ECE/TRANS/WP.29/GRRF/2007/28  
16 July 2007

Alignment of Regulations Nos. 13 and 13-H

Proposal for amendments to Regulation No. 13-H  
(Braking)

Submitted by the expert from the European Commission (EC)

**Figure 1** Steering wheel position and yaw velocity information used to assess lateral stability.

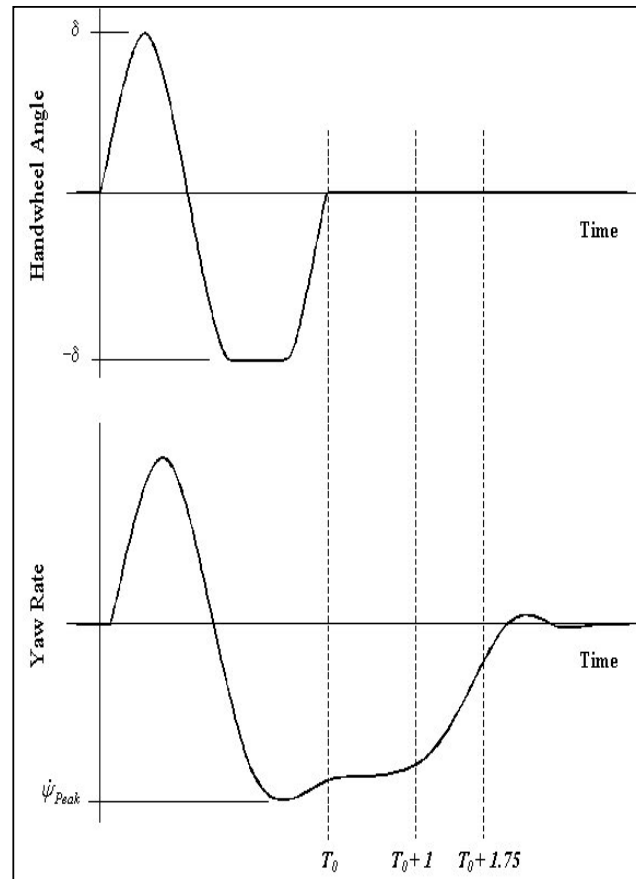
- 3.1. The yaw rate measured 1 second after completion of the sine with dwell steering input (time  $T_0 + 1$  in Figure 1) shall not exceed 35 percent of the first peak value of yaw rate recorded after the steering wheel angle changes sign (between first and second peaks) ( $\dot{\psi}_{Peak}$  in Figure 1) during the same test run.

- 3.2. The yaw rate measured 1.75 seconds after completion of the Sine with Dwell steering input shall not exceed 20 percent of the first peak value of yaw rate recorded after the steering wheel angle changes sign (between first and second peaks) during the same test run.
- 3.3. The lateral displacement of the vehicle centre of gravity with respect to its initial straight path shall be at least 1.83 m for vehicles with a GVM of 3,500 kg or less, and 1.52 m for vehicles with a GVWR greater than 3,500 kg when computed 1.07 seconds after the Beginning of Steer (BOS). BOS is defined in paragraph 5.11.6.

Figure 2 Sine with Dwell

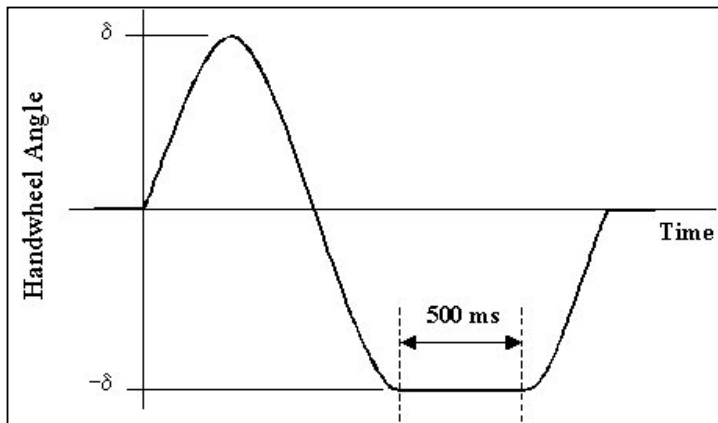
The vehicle is subjected to two series of test runs using a steering pattern of a sine wave at 0.7 Hz frequency with a 500 ms delay beginning at the second peak amplitude as shown in Figure 2 (the Sine with Dwell tests). One series uses anticlockwise steering for the first half cycle, and the other series uses clockwise steering for the first half cycle. The vehicle is allowed to cool-down between each test run for a period of 1.5 to 5 minutes, with the vehicle stationary.

- 5.9.1. The steering motion is initiated with the vehicle coasting in high gear at  $80 \pm 2$  km/h.
- 5.9.2. The steering amplitude for the initial run of each series is 1.5 A, where A is the steering wheel angle determined in paragraph 5.6.1.

- 5.9.3. In each series of test runs, the steering amplitude is increased from run to run, by 0.5 A, provided that no such run will result in a steering amplitude greater than that of the final run specified in paragraph 5.9.4.

- 5.9.4. The steering amplitude of the final run in each series is the greater of 6.5 A or 270 degrees, provided the calculated magnitude of 6.5 A is less than or equal to 300 degrees. If any 0.5 A increment, up to 6.5 A, is greater than 300 degrees, the steering amplitude of the final run shall be 300 degrees.
